Alternative Years at James Martin Request For Proposals ADDENDUM #5

September 8, 2022

1. OPA Property Information Web Page for 3350 Richmond Street

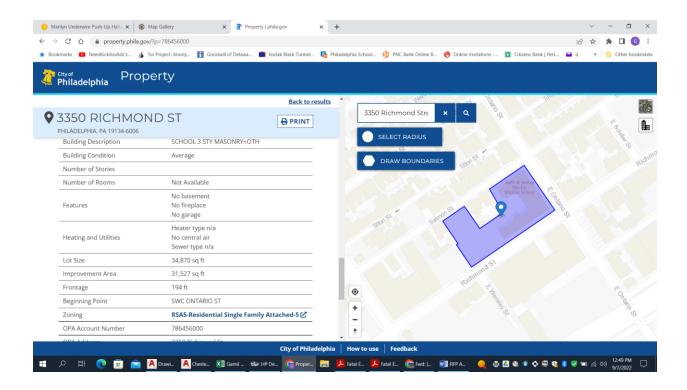
Question 1: The response to question 1 [in Addendum #3] is in conflict with the updated map that was provided in the addendum. We (KSS/DMA/SS) were looking at the zoning maps end of day yesterday and the information is confusing. Graphically it appears the various properties highlighted as the project site in the addendum are all separate lots; but they all populate with the address 3350 Richmond Street and owner as the school district. So we need to confirm the project boundary, and if lots are all consolidated or not.

Answer: According to City records, the lot is one parcel. An image of the Office of Property Assessment map is attached at the end of this addendum.
